NEW MEXICO
ENVIRONMENT DEPARTMENT

Hazardous Waste Bureau

**RE: SECOND NOTICE OF DISAPPROVAL
RCRA FACILITY INVESTIGATION
WORK PLAN FOR PARCEL 6
FORT WINGATE DEPOT ACTIVITY
EPA ID# NM6213820974
FWDA-08-001**

Figure 8-5

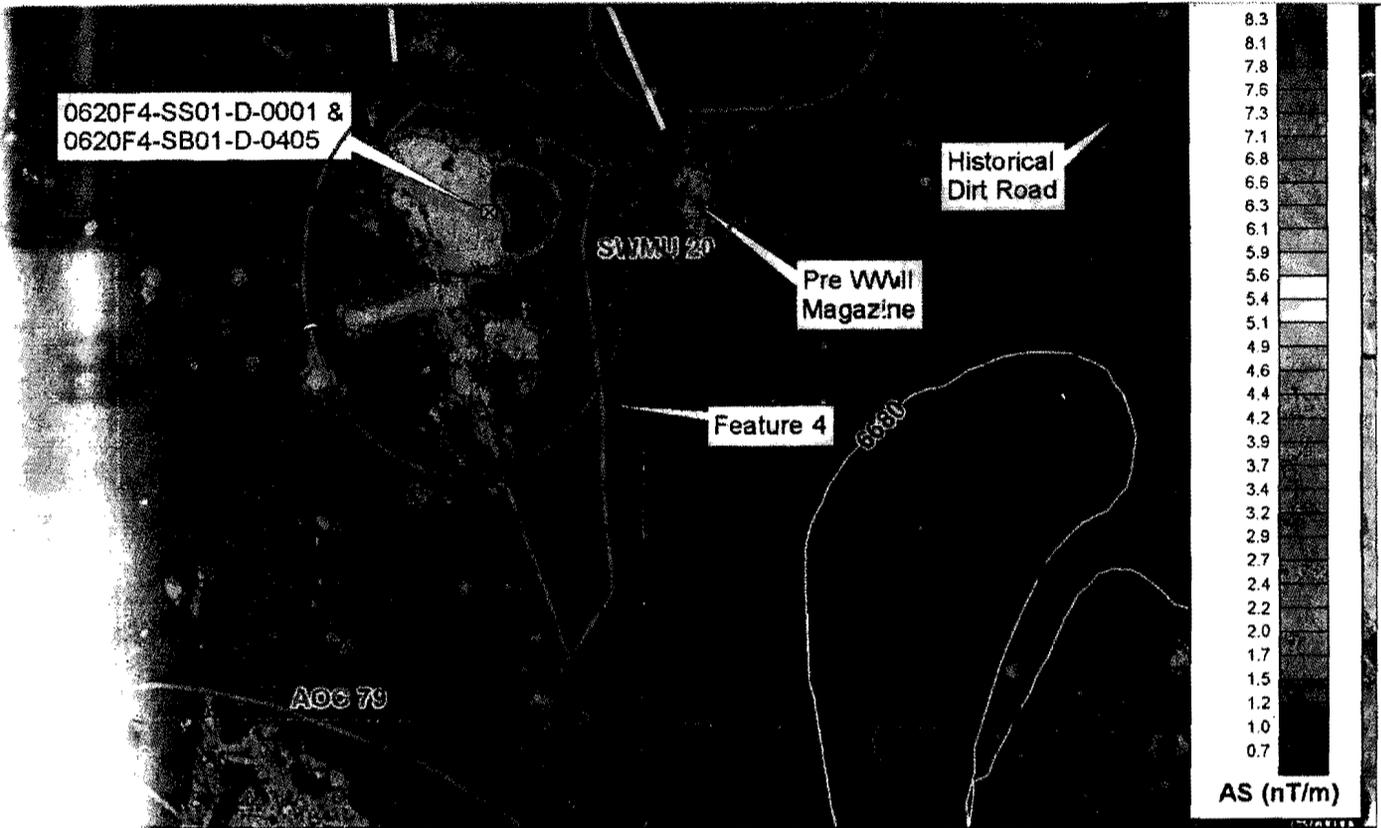
In Section 8.3.2 (Media Characterization), page 8-14, the Permittee states “[i]n January, 2009, a low altitude airborne vertical magnetic gradient geophysical survey was conducted over the Fort Wingate Army Depot, New Mexico.” The Permittee also states that “[t]he results of the airborne geophysical survey for SWMU 20 are shown in Figure 8-5.” Based on the results shown in Figure 8-5, it appears that many geophysical anomalies were not investigated or removed throughout SWMU 20. With the exception of the railroad classification yard and SWMU 25, the Permittee must therefore identify and remove all waste associated with geophysical anomalies at the locations identified by NMED in the attached Figure 8-5. The Permittee must also determine whether hazardous constituents have been released to the environment. The waste must also be profiled for proper disposal. The Permittee must revise the Work Plan to include the proposed characterization and removal actions.

NMED's proposed locations for
further investigation
